Amendments to the Drawings

The attached replacement sheets of drawings includes changes to FIGS. 3, 4B, and 5A and replaces the original sheets 2/7 and 4/7.

FIG. 3

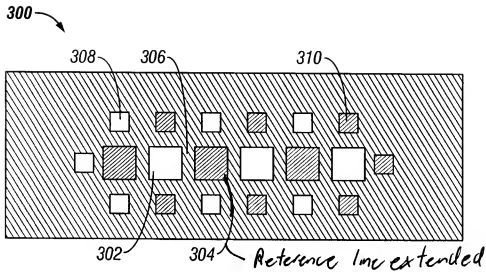
In FIG. 3, the reference line for reference numeral "304" has been extended to reach a primary pi aperture, as described in para. [0020].

FIG. 4B

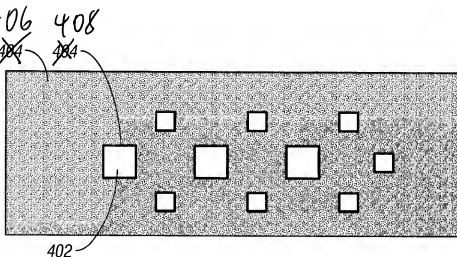
In FIG. 4B, the reference numeral "406" has been used to indicate resist, as described in para. [0021]. Also, inadvertent duplication of reference numeral "404" has been corrected by denoting the open apertures with numeral "408." This change has also been made in the specification.
